Victoria International Marina

South-facing mechanical screen on restaurant building application

Rooftop Mechanical Equipment

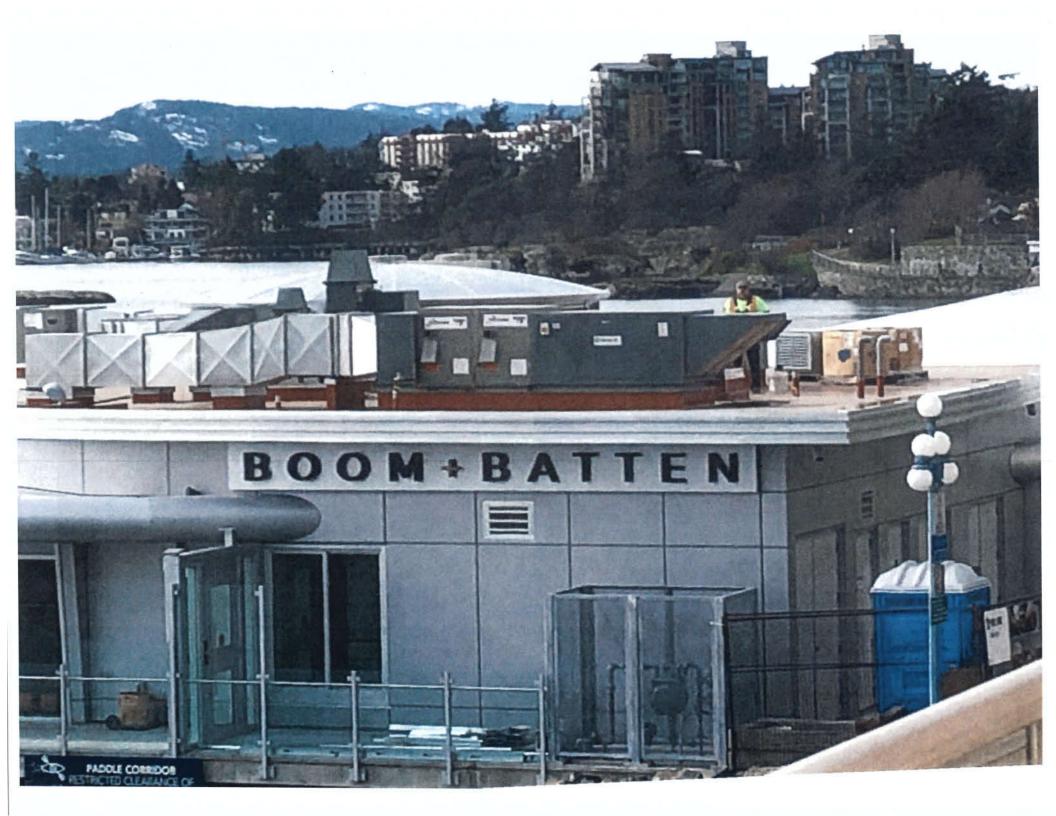
We came back from Mexico early. Had a look at the drawings for the screen and at 900cm is not high enough, in our opinion. It is our opinion that 1.2m would be more appropriate, preferably with an inward overhang at say 45 degrees? Another observation is it would be a help if they painted all he units to an aluminum/silver colour.
